STAFF REPORT SAN CLEMENTE PLANNING COMMISSION

SUBJECT: Architectural Permit 14-329, Site Plan Permit 14-346, and Minor Conditional Use Permit 14-347, Estrella Shopping Center (Phase I), a request to consider a façade enhancement for an existing shopping center and a request for the sale of beer and wine for off-site consumption located at 550 Camino de Estrella within the Community Commercial (CC-2) zoning district. This is for the portion of the project site that was the K-Mart facility.

To: Design Review Subcommittee
 From: Sean Nicholas, Associate Planner
 Subject: Preliminary Design Review-Estrella Shopping Center Remodel
 Copies: Jim Pechous, City Planner

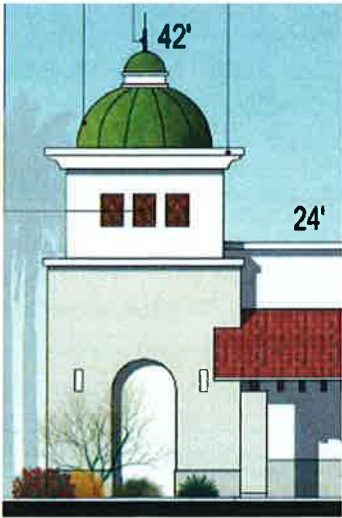
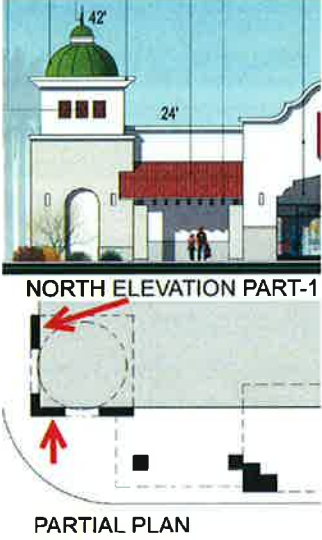
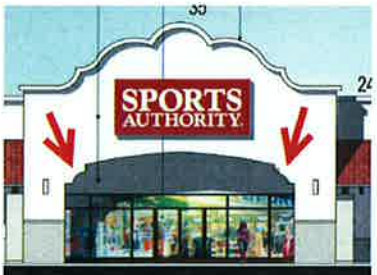
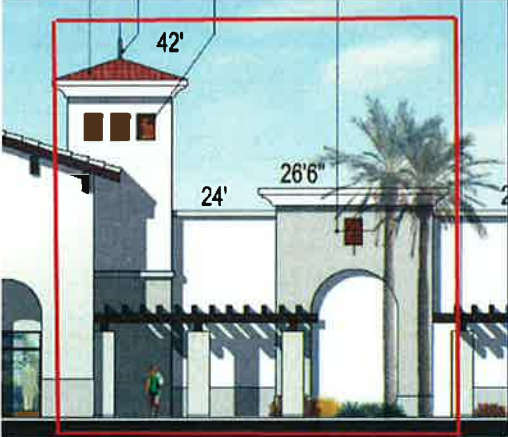
The previous submittal reviewed by DRSC had several issues of concern, most notably massing and proportionality. The applicant has taken these comments and revised the development to be more consistent with the Design Guidelines and General Plan requirements of Spanish architecture.

To move the design of the project forward to Planning Commission, and to ensure consistency with the Design Guidelines, staff has developed the following recommendations. Table 1 provides a breakdown of the proposed design elements, staff's recommendation, and the basis for the recommendation. Staff seeks Design Review Subcommittee's comments and recommendations.

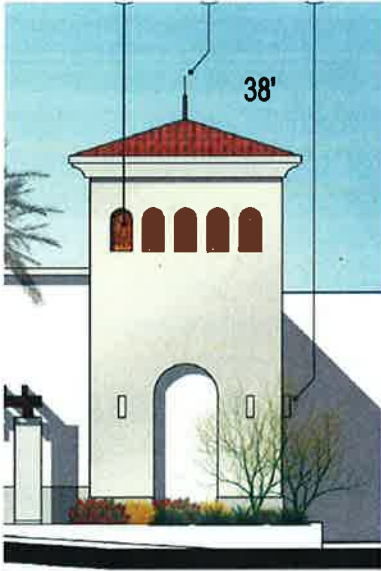
Proposed Element	Staff Recommendation	Basis for Recommendation
<p>Staff is supportive of the dome element of the tower, though some additional detail and scaling needs to occur.</p> 	<p>These are examples from the similar Ralphs tower that staff feels will enhance the design.</p> 	<ol style="list-style-type: none"> 1. The proportions of the tower seem off. The lower horizontal plane break should be higher above the 24 foot primary roof line. 2. Adding the simple decorative features at the corners of the lower break will fill in those areas appropriately. 3. The cornice under the dome should be reduced and simplified. 4. The arch at the bottom should be widened and increased in height and utilization of a similar stone cap around the arch would be beneficial to the design.
